Implementing an Extinction Ratio of 3.5 dB in 50GBASE-FR/LR in P802.3cd

Xi Huang, Yu Xu, Peter Stassar

Introduction

BER performance 50G PAM4 Rx versus ER

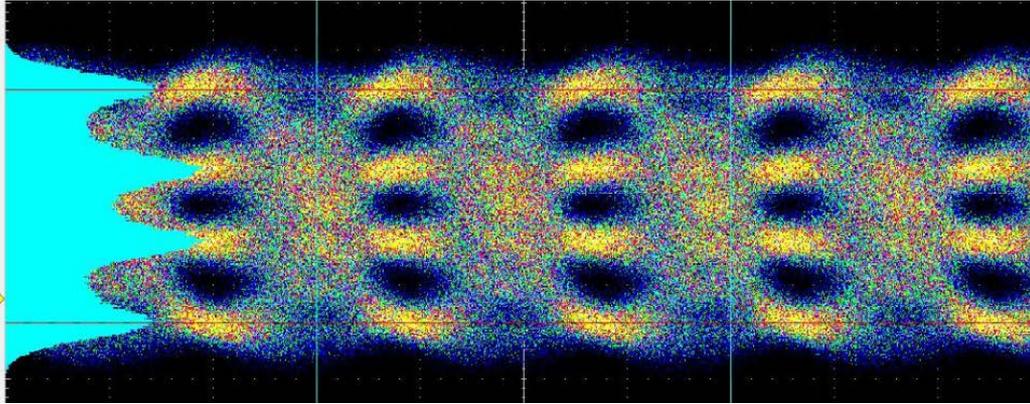
Margin >4 dB against -8.8 dBm LR (unstressed) receiver sensitivity spec for perfect transmitter (SECQ = 0dB)

Actual margin even bigger because test transmitter will have SECQ > 0dB

- The shown test results demonstrate a margin of more than 4 dB against the specified receiver sensitivity ($\text{OMA}_{\text{outer}}$) (max) of -8.8 dBm for 50GBASE-LR and more than 5.5 dB for the 50GBASE-FR specification of -7.3 dBm.
- 50GBASE-LR and FR receiver (unstressed) sensitivity values are for a perfect transmitter, so more margin in this test, assuming that test transmitter has $\text{SECQ} > 0\text{dB}$.
- These results support the suggestion that even after tightening the receiver sensitivities of 50GBASE-FR/LR by 0.1 dB there would still be more than sufficient margin to allow low cost manufacturing of receivers for both applications.
